## HISTORIC AND DESIGN REVIEW COMMISSION

Agenda Item No: 21

**HDRC CASE NO:** 2016-452  
**COMMON NAME:** 100 N Main  
**LEGAL DESCRIPTION:** NCB 909 BLK LOT A8 & A 9  
**ZONING:** D S H HE RIO-3  
**CITY COUNCIL DIST.:** 1  
**DISTRICT:** Main/Military Plaza Historic District  
**LANDMARK:** Bell Furniture / Wolfson's  
**APPLICANT:** Randy Kelly/JRK Design  
**OWNER:** REM Hospitality  
**TYPE OF WORK:** Approval of signage master plan, landscaping, street level elements  
**REQUEST:**

The applicant is requesting a Certificate of Appropriateness for outstanding items specific to the new construction at 100 N Main. At this time, the applicant is requesting a Certificate of Appropriateness for:

sheet number  
**A602**

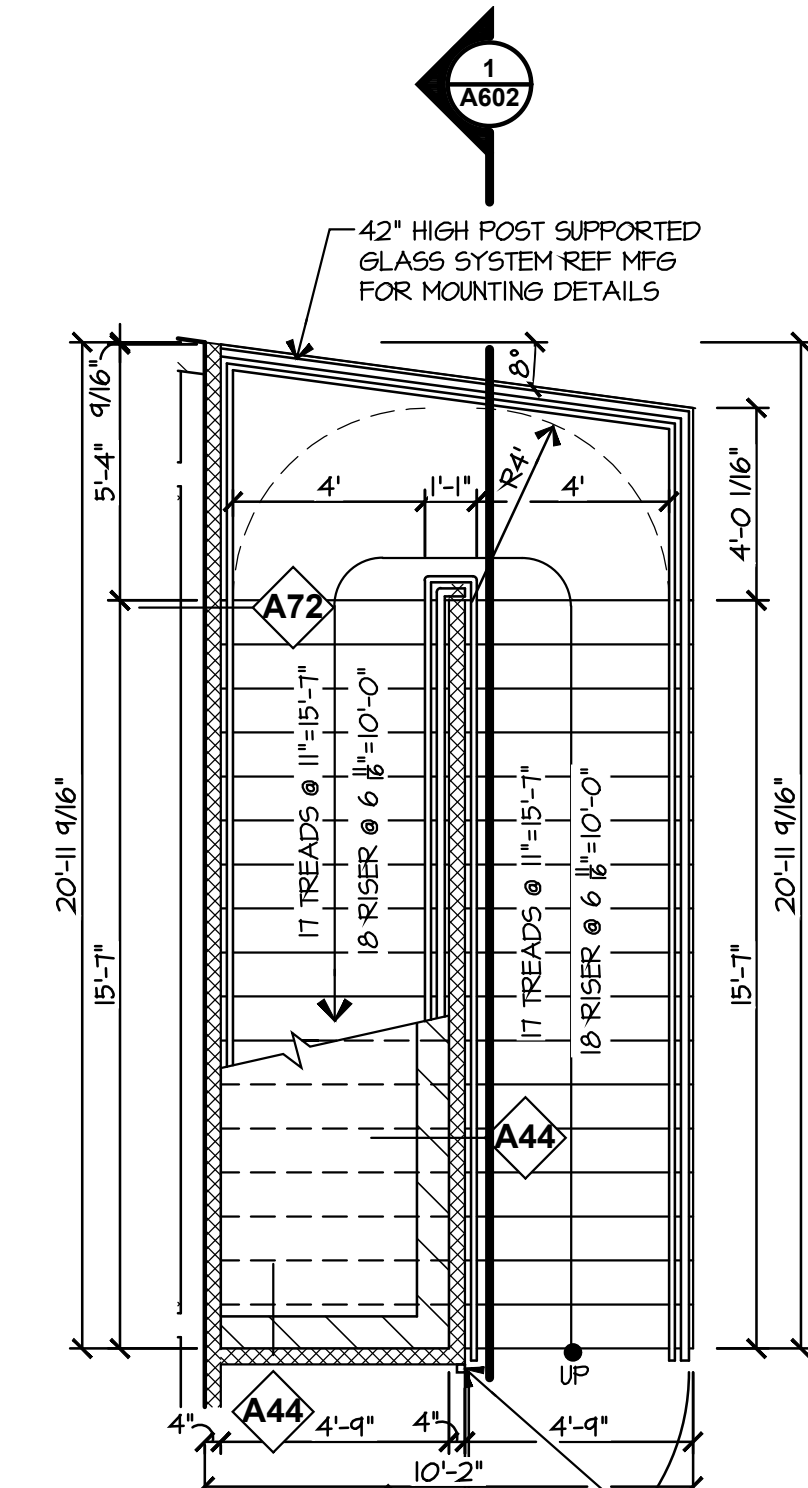
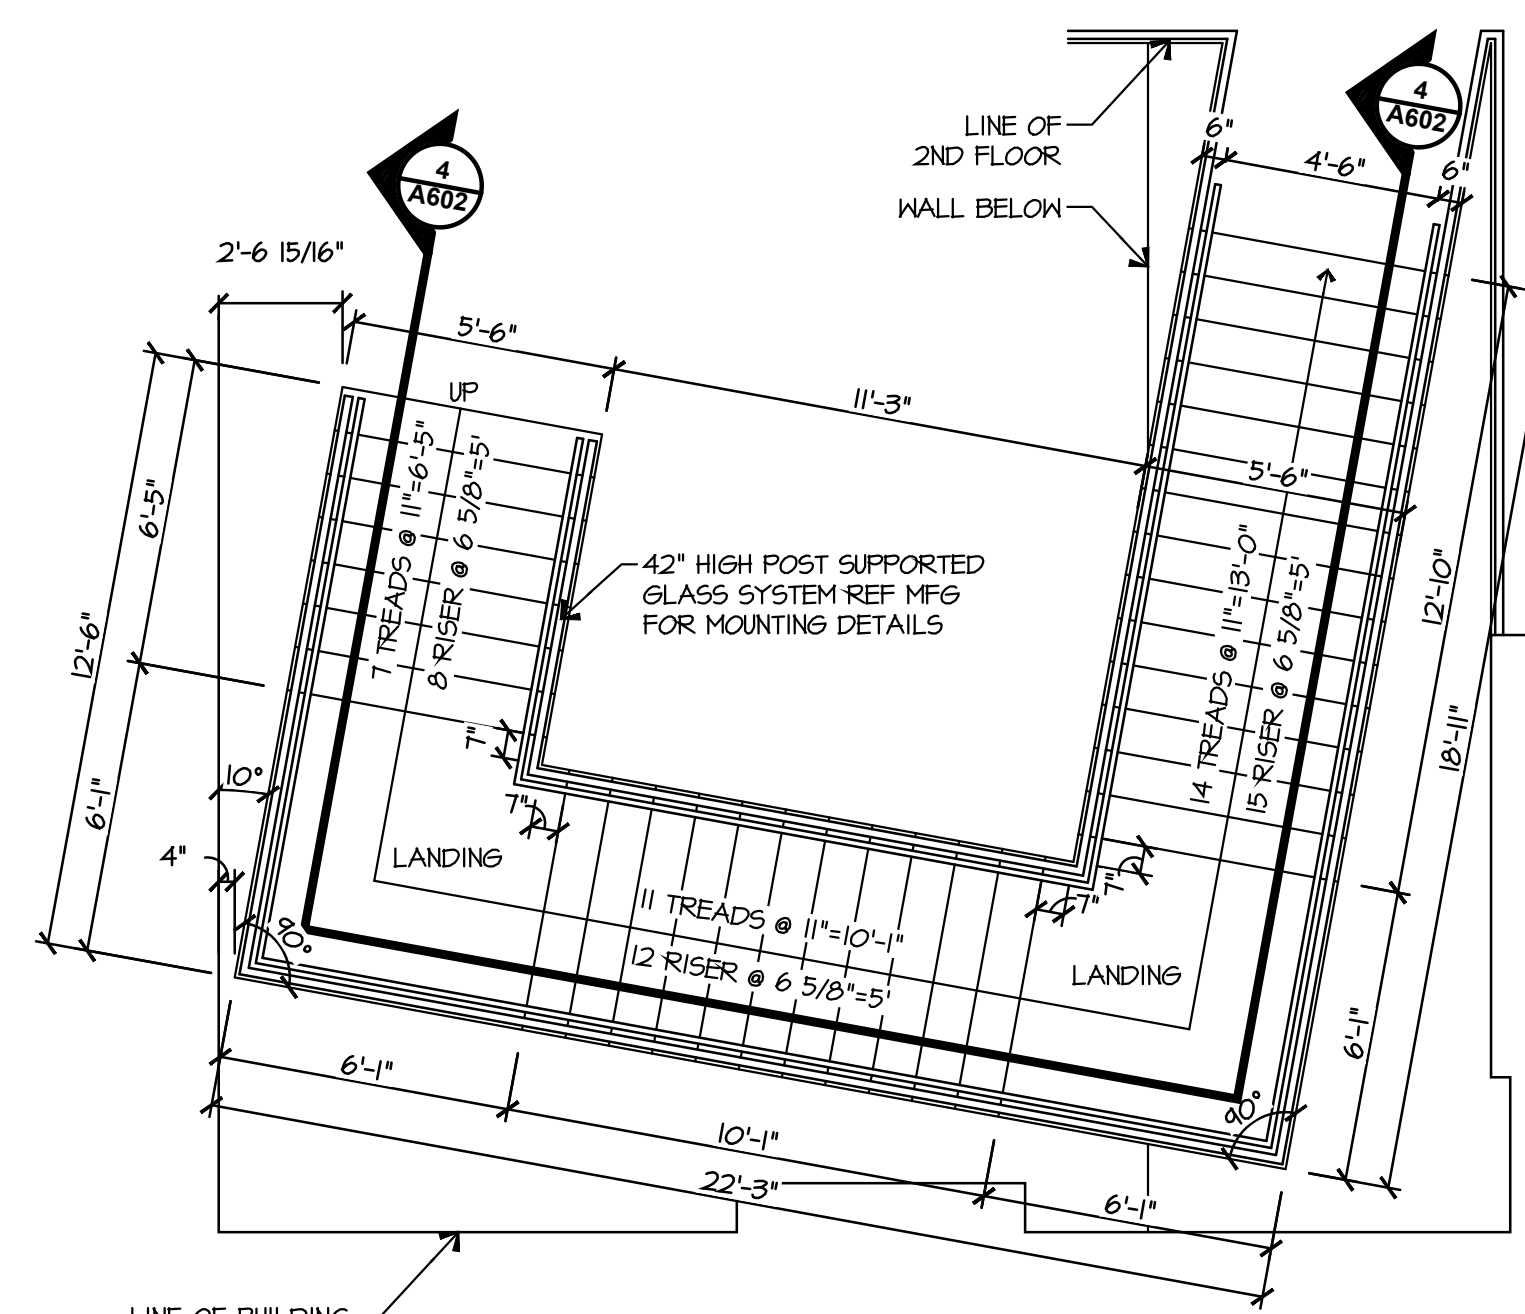
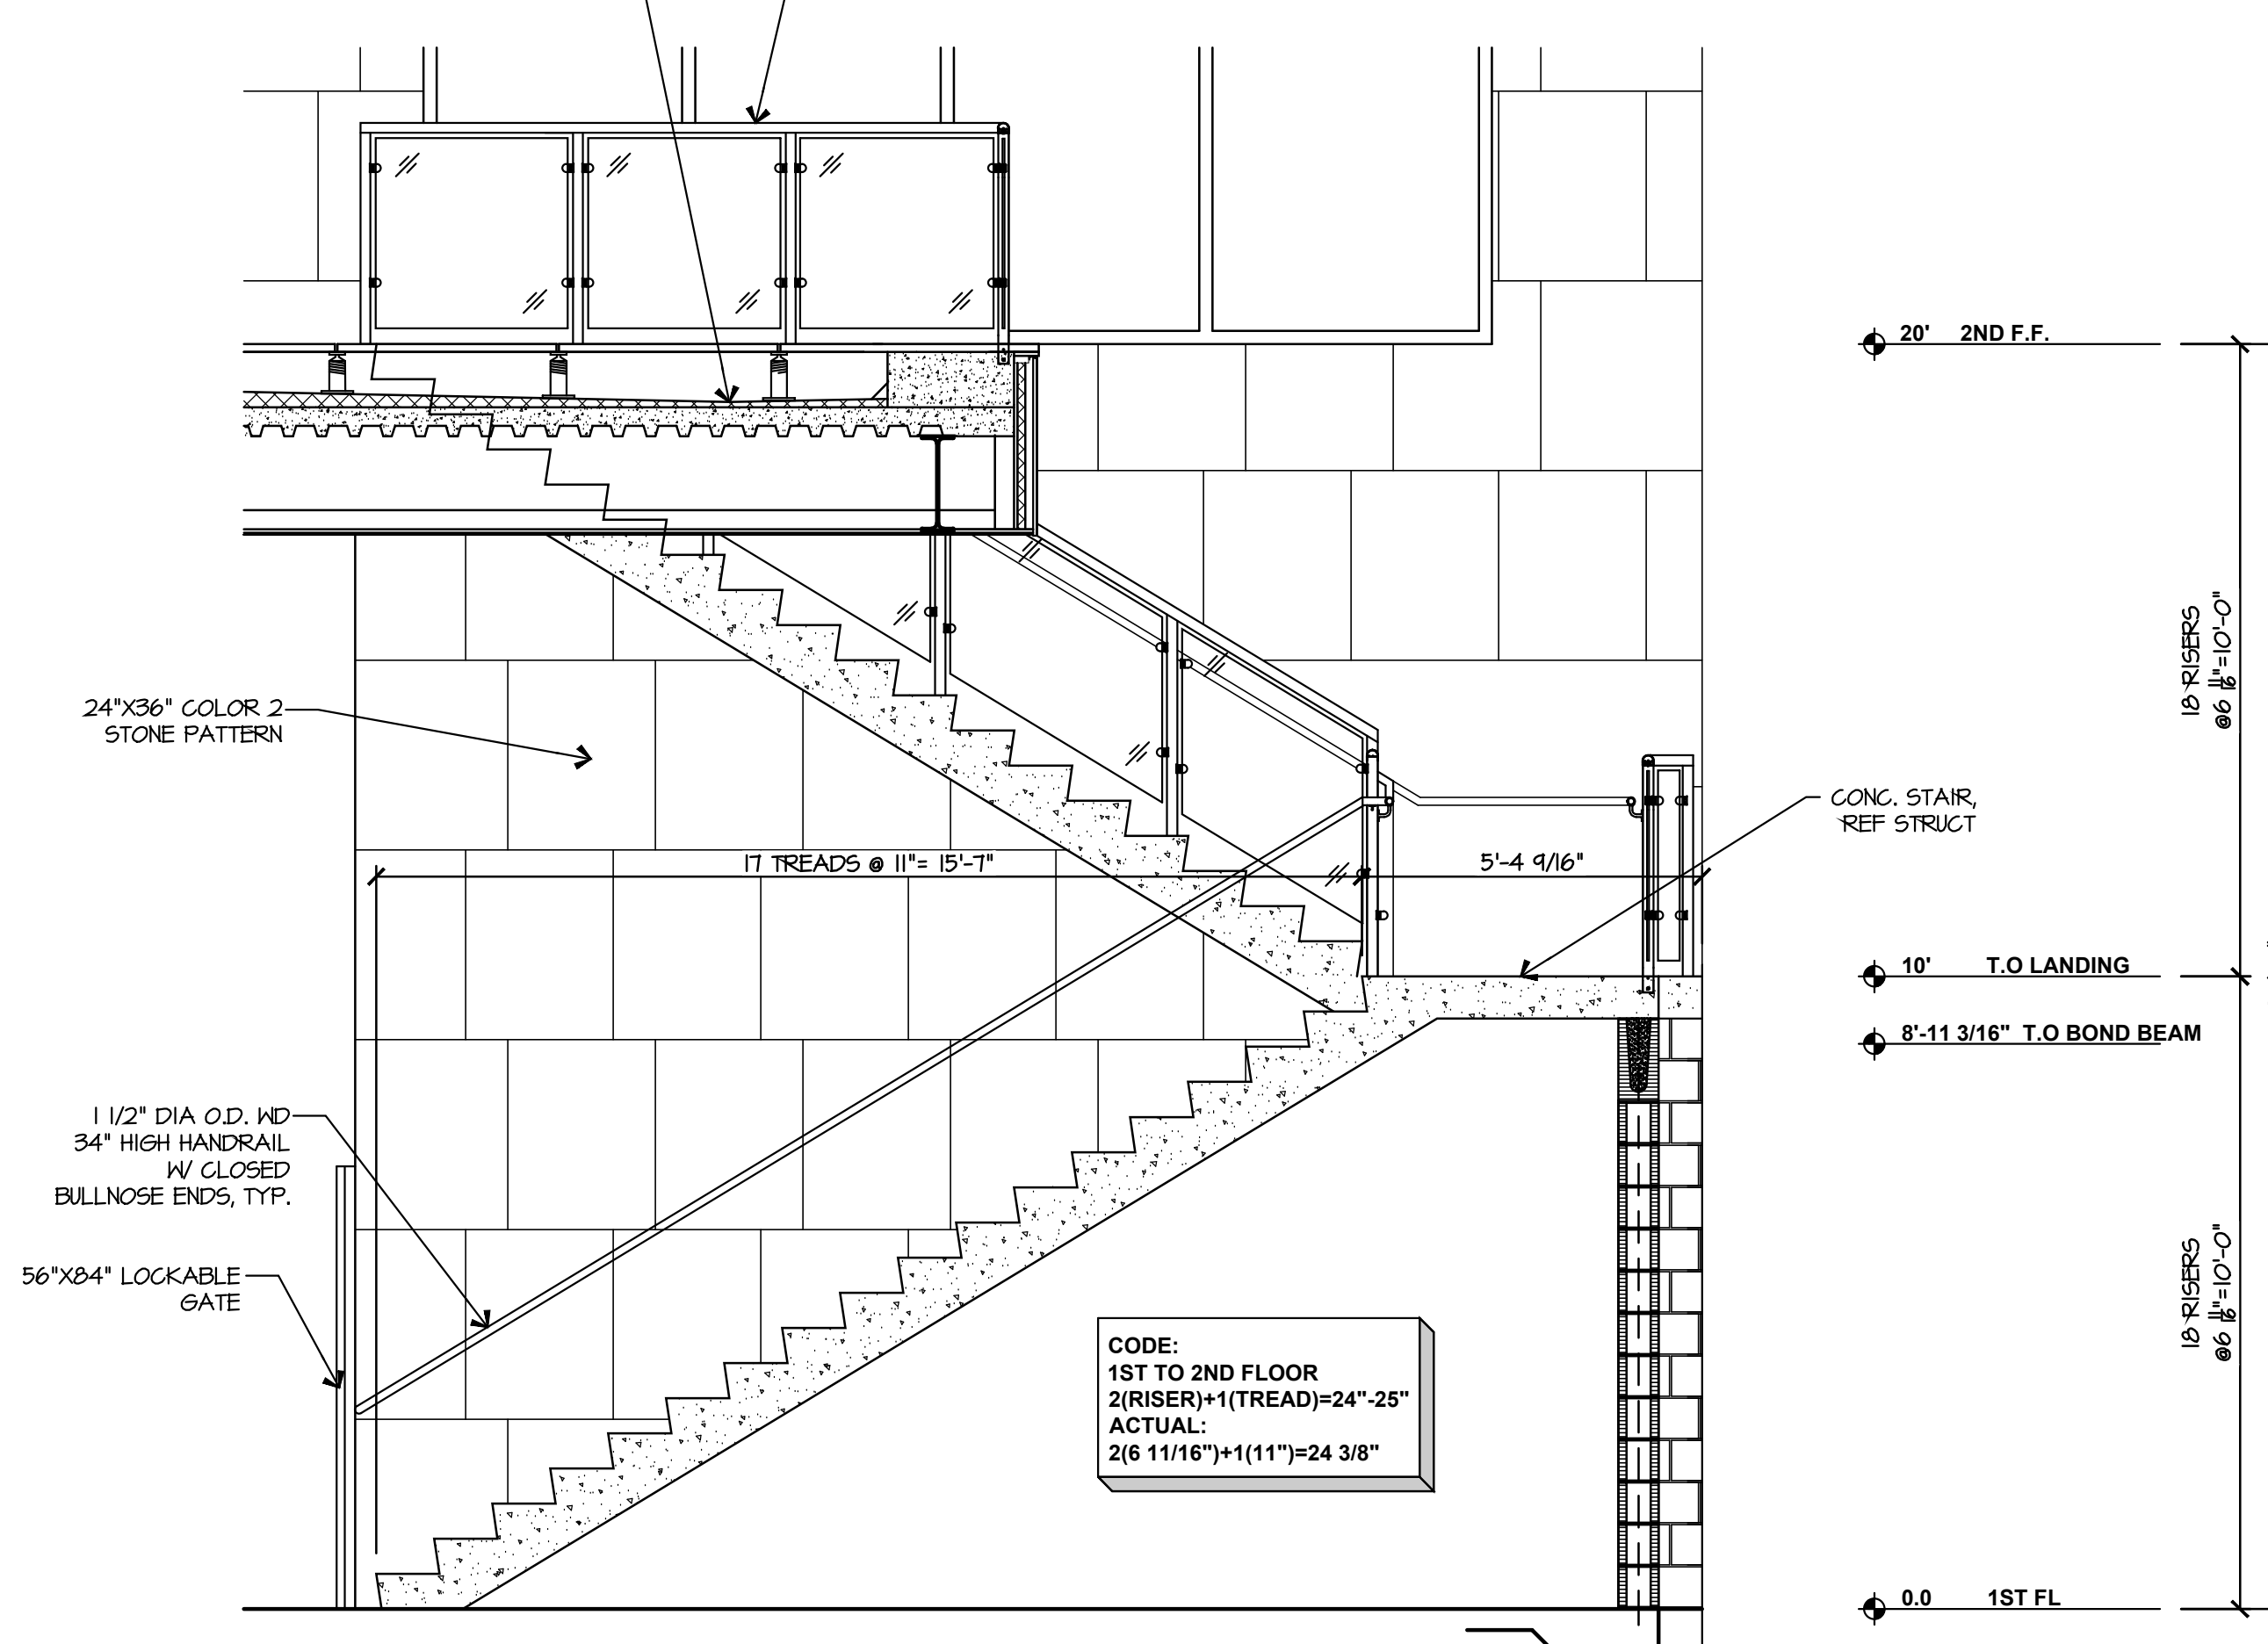
- b. STAIR DETAIL – At the street level, the applicant has provided a detail which notes the installation of a lockable gate which is to measure 56 inches in width and 84 inches in height. Staff finds that a gate exceeding six (6) feet in height at this location is inappropriate. Staff recommends the applicant reduce the height of the gate to not exceed six (6) feet in height. Additionally, the proposed gate should match the stair railings in materials, finishes and detailing.

1. See sheet A602 for the stair plan, elevation and section showing the gate and specs for the gate to secure the 2<sup>nd</sup> floor balcony after hours.
2. See civil drawing set in response to the side walk remaining at the constant level.
3. See Landscape plan and specs.
4. See A300 for the proposed exterior signage.
